DESCRIPTIVE REPORT

Field No. HO-5-1-62 Office No. H-8658

Locality Kake to Hamilton Island

HYDROGRAPHIC SURVEY H-8658
(Field No. HO-05-1-62)

H-8658
INSERT OF CHART 8201

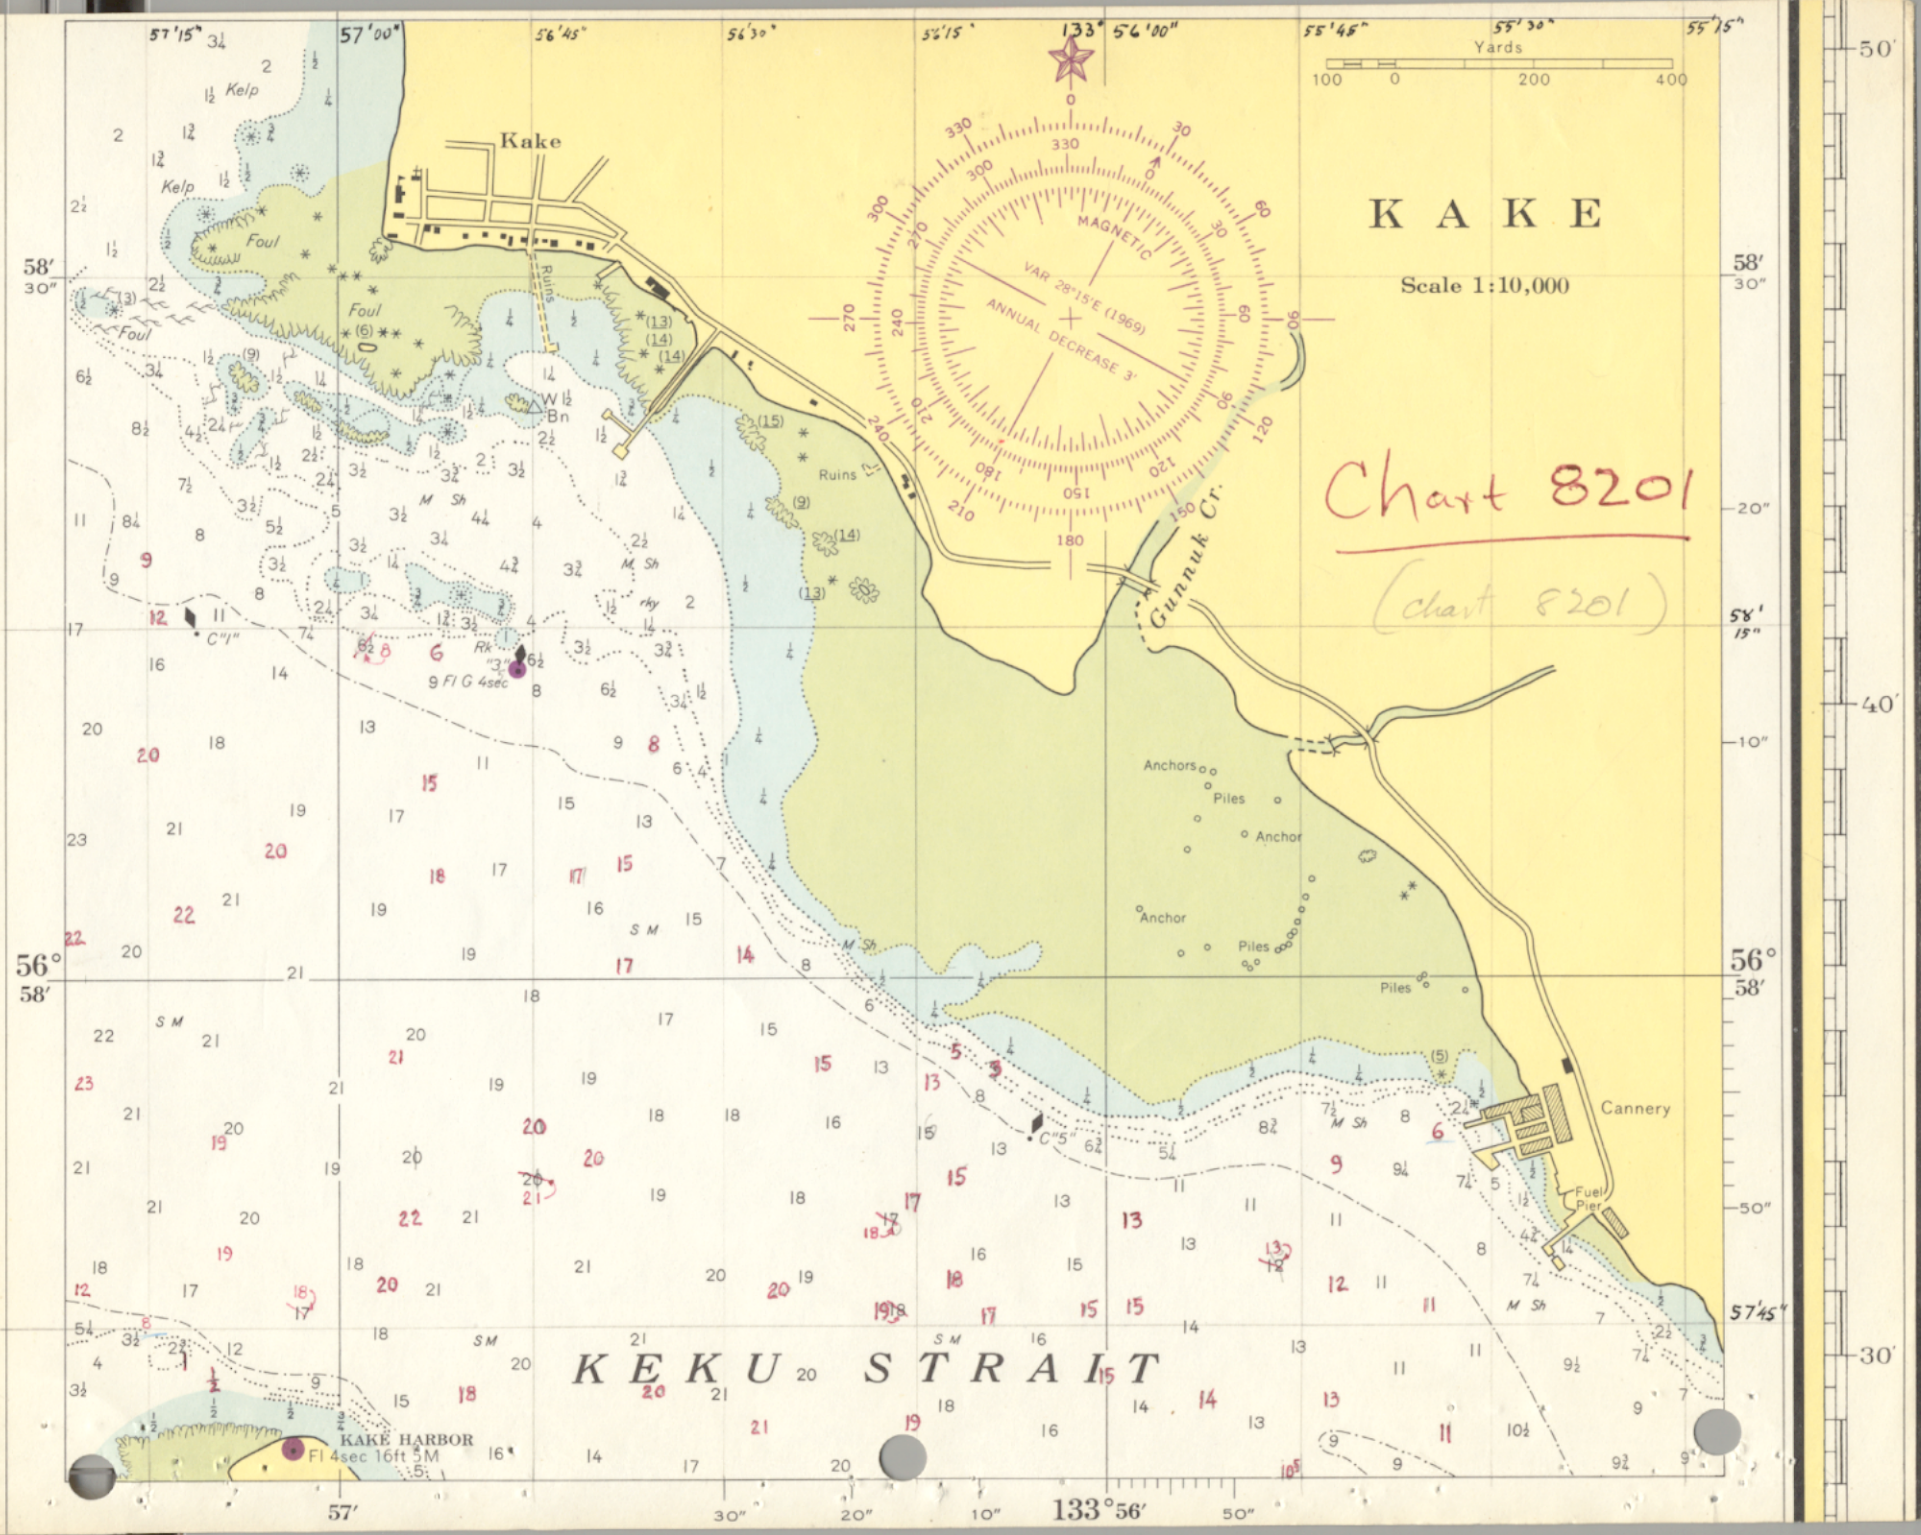
(4) The $\frac{1}{4}$ -fm. sounding charted at lat. $56^{\circ}57.40'$, long. $133^{\circ}54.48'$ on the Portage Bay inset originates with the boat sheet of the present survey on which it is an error. The correct sounding is 3 fathoms. *8175*
cert to 9175
selected diff. here

(6) The $\frac{3}{4}$ -fm. sounding charted on the Portage Bay inset at lat. $56^{\circ}57.26'$, long. $133^{\circ}55.35'$ originates with the boat sheet of the present survey. The correct depth in this position is 2.8 fathoms. *8175*

(7) The 7-fm. sounding charted on the Portage Bay inset at lat. $56^{\circ}56.98'$, long. $133^{\circ}55.23'$ from the boat sheet of the present survey has been revised to 10.7 fathoms on the smooth sheet. *8175*

(9) Several charted elevations of reefs on the Portage Bay inset originate with the boat sheet of the present survey where the values are incorrectly shown. These elevations should be charted as shown on the smooth sheet of the present survey. ✓ 8175
